PCN# : P544AAB
Issue Date : May. 15, 2015

DESIGN/PROCESS CHANGE NOTIFICATION

Top & side view

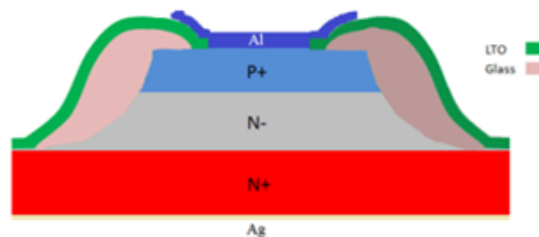
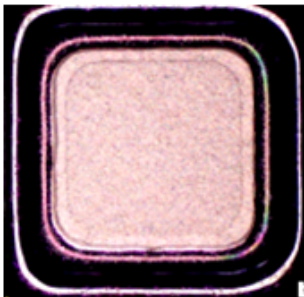
Description of Change (From) :

Fab process : GPP (Glass Passivation Process)

Top & side view

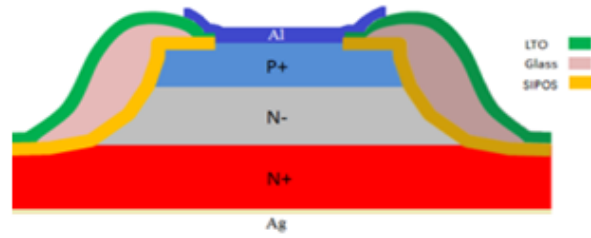
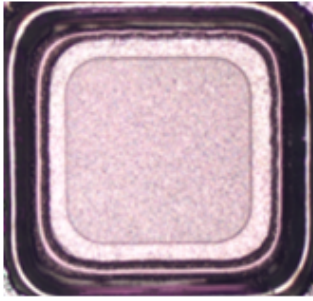
Description of Change (To) :

Fab process: GPP with SIPOS (Semi-Insulation Polycrystalline Silicon)

SIPOS technology will improve production stability and increase the quantity of final output.
and after SIPOS implementation there will be no change in either datasheet limit or die/package's physical dimension.
